# **Technical Journal**

## **T8 P0EA773 Auxiliary Cooling System Performance**

REF NO: TJ 34123.1.3			CAR MARKET: United States and Canada		
10 04120.110	Teomineal Gervice	Omitou otatot	- and Ganada		
	PARTNER:	ISSUE DATE:	STATUS DATE:		
3 US 7	510 Volvo Car USA	2018-10-23	2018-10-31		
FUNC GROUP:	FUNC DESC:				
2647	Heater, thermostat	Page	1 of 3

## **Technical Journal 34123.1.3**

Note: Orientation of the component is critical to correct operation. See attached photo US34123\_ Orientation Illustration.jpg

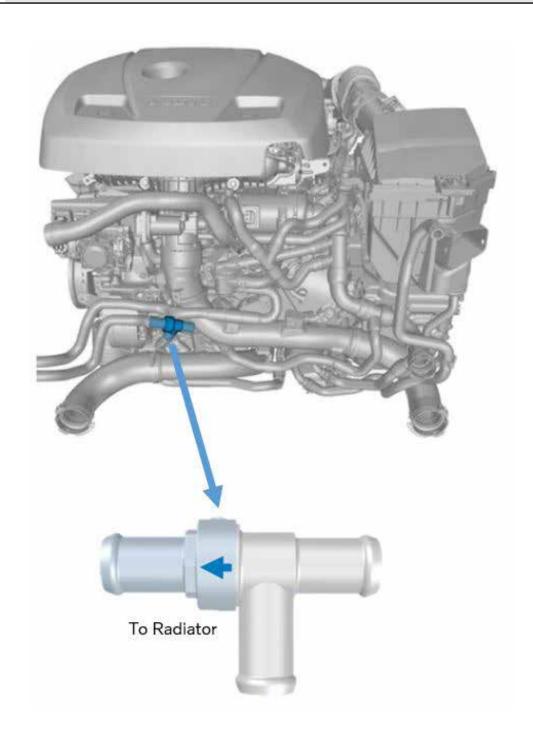
A new component is now available for replacement and the old thermostat part number has been blocked. Do not install old stock on shelves.

Please order and install component 32139082.
